SENDLEWSKI ARCHITECTS, PC
ARCHITECTS – PLANNERS

ADDENDUM NO. 1
ISSUED 08-15-22

FIREHOUSE FACILITY PROJECTS
TAPPAN FIRE DISTRICT
PROJECT No. 2108.01A, 2108.01B, 2108.02

A=1

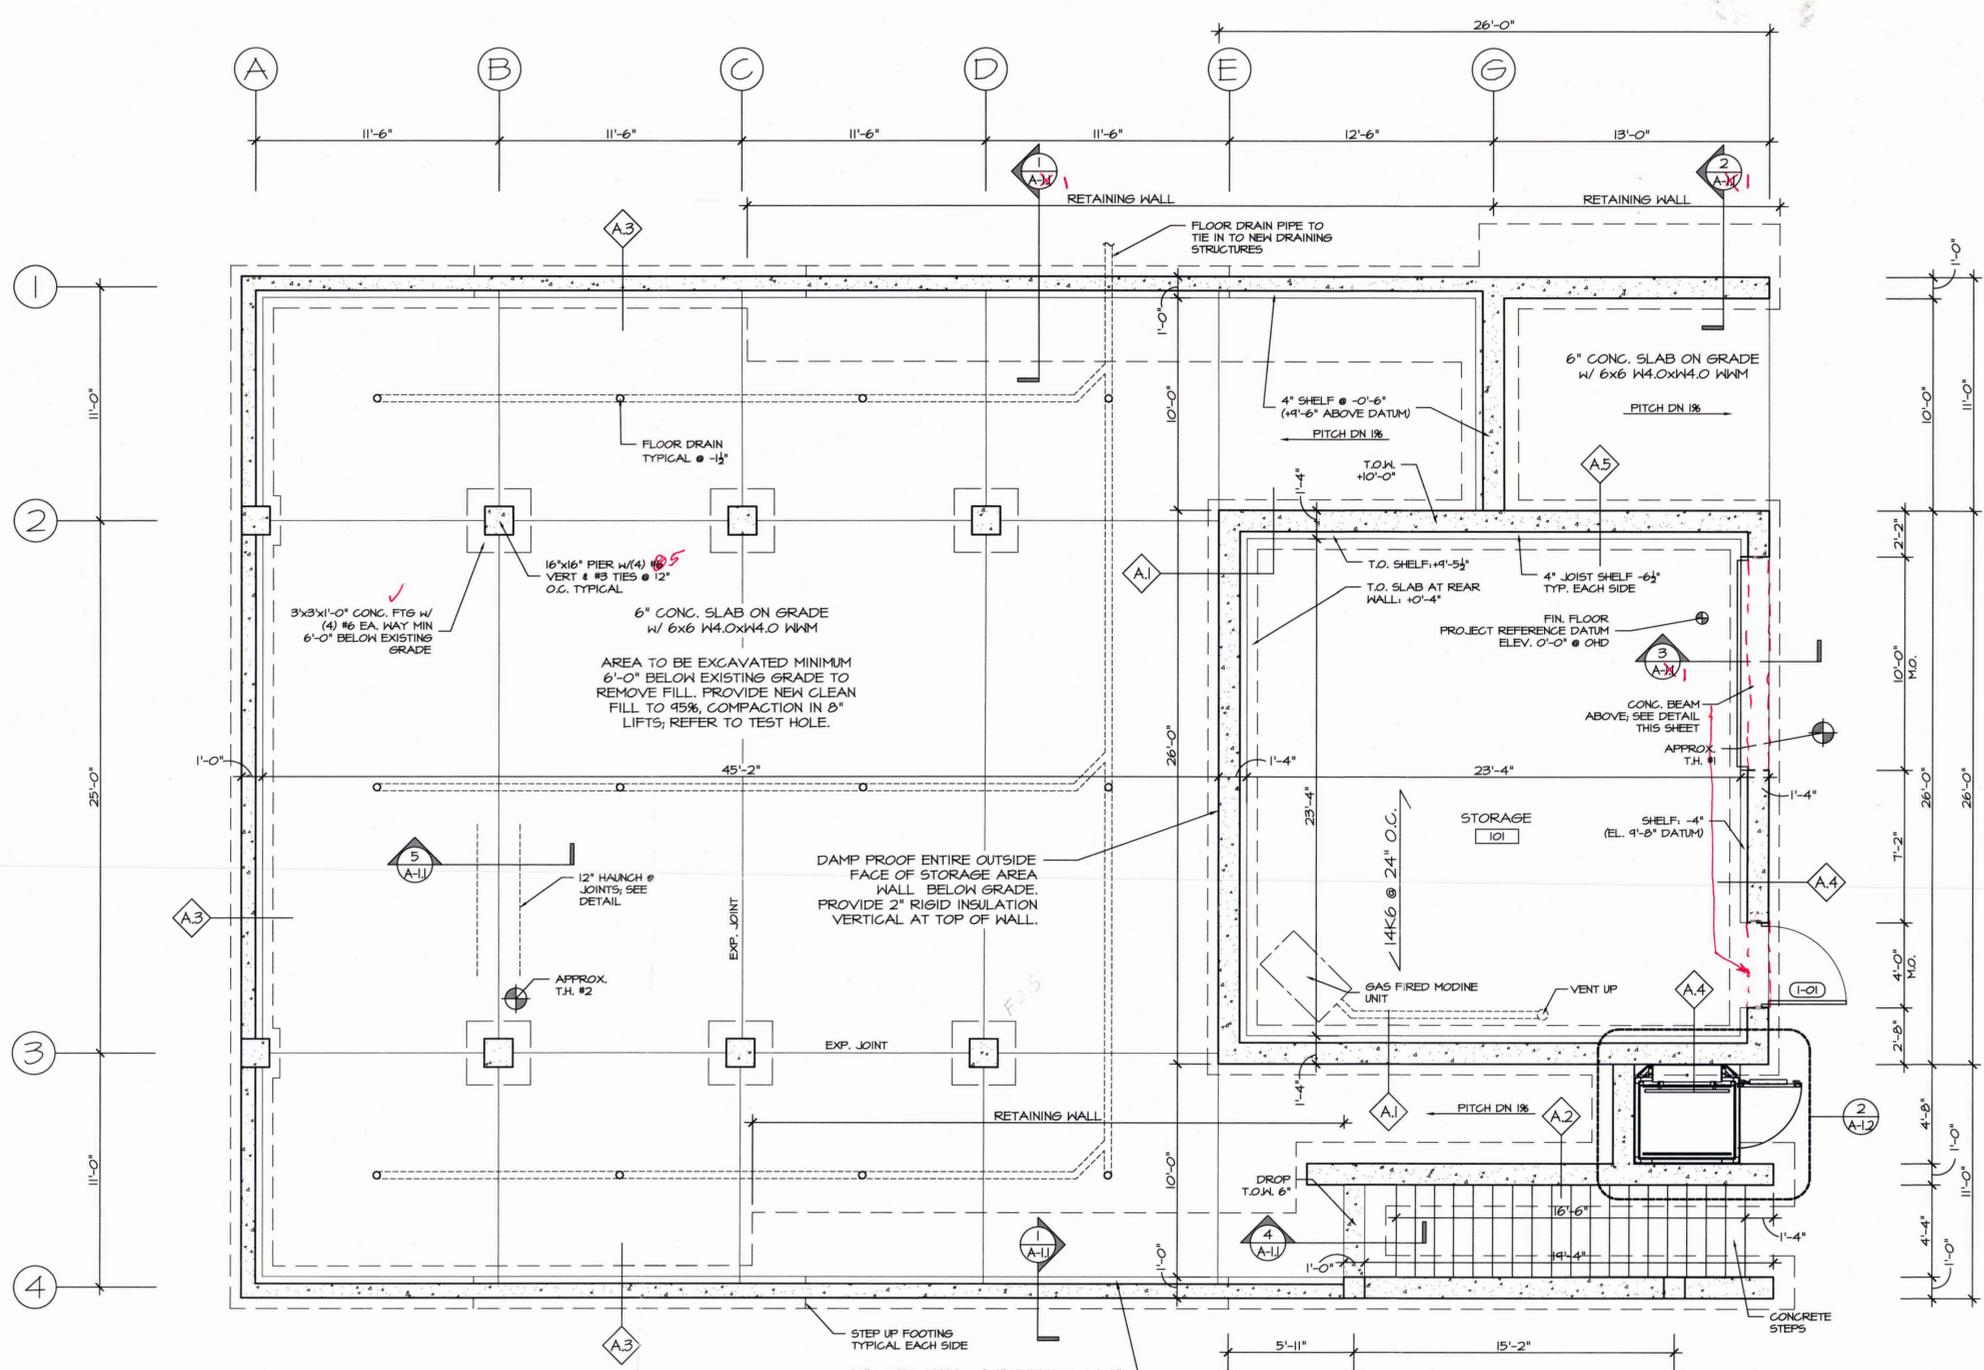
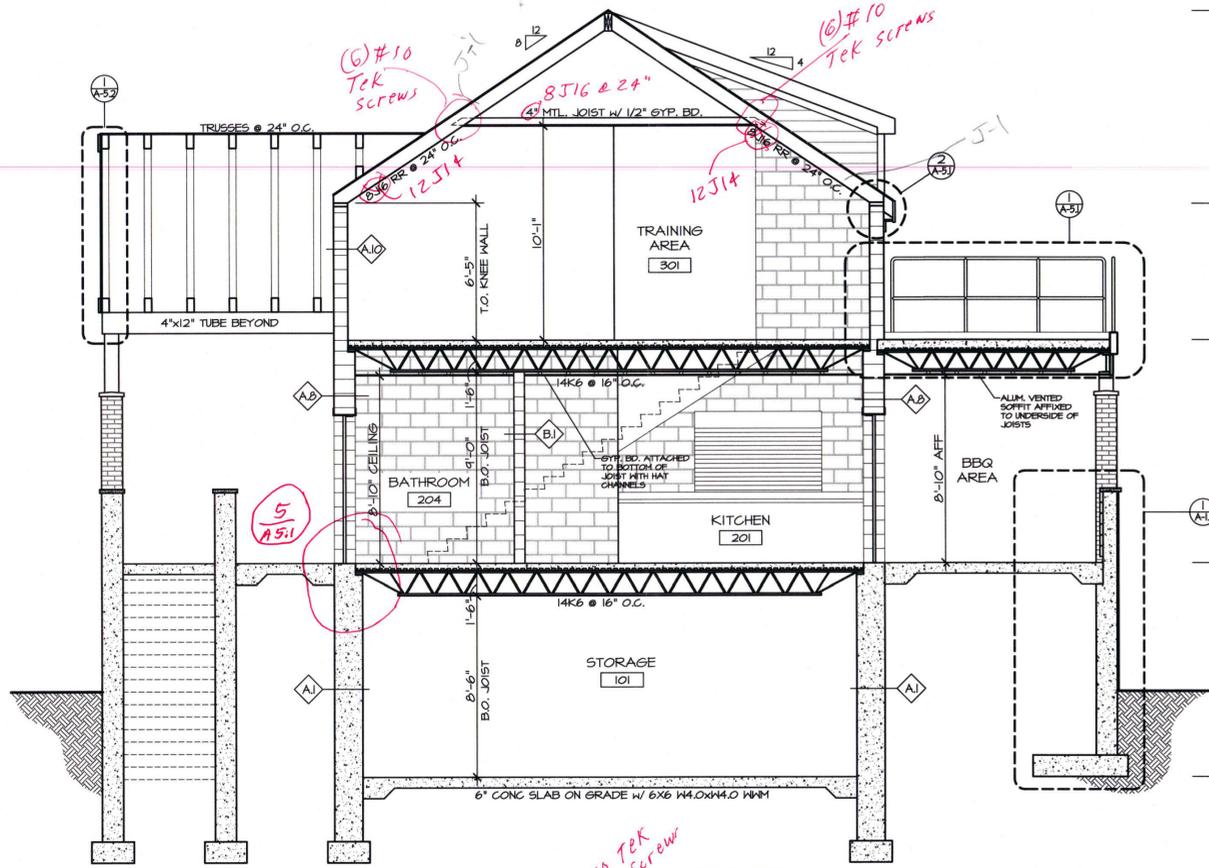
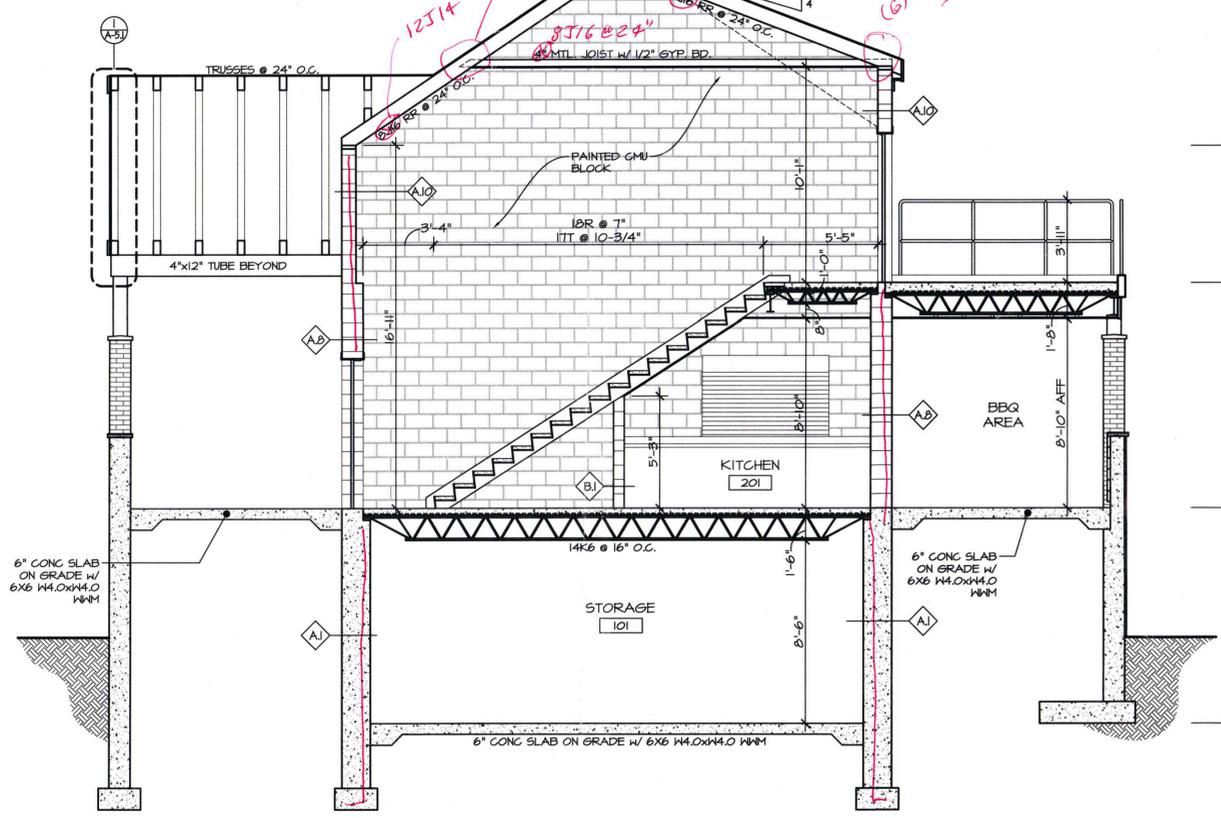
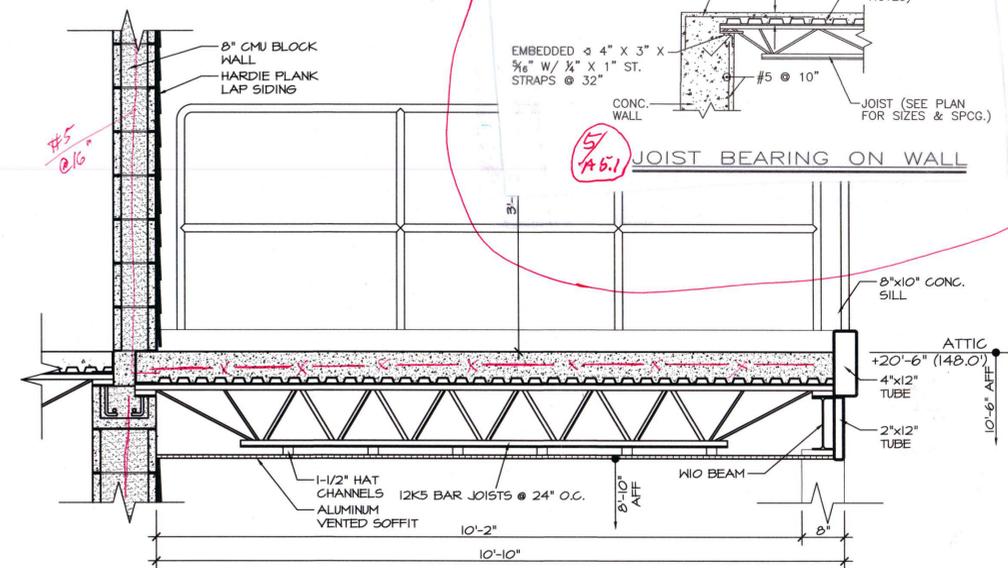
- **A-1** - Added notes to Lower Level Plan, and changes to Details 1 & 2.
 - **A-2** - Changes to Detail 1.
 - **A-5.1** - Changes/Notes on Sections A & B, Section 1, and Detail 2 & 3.
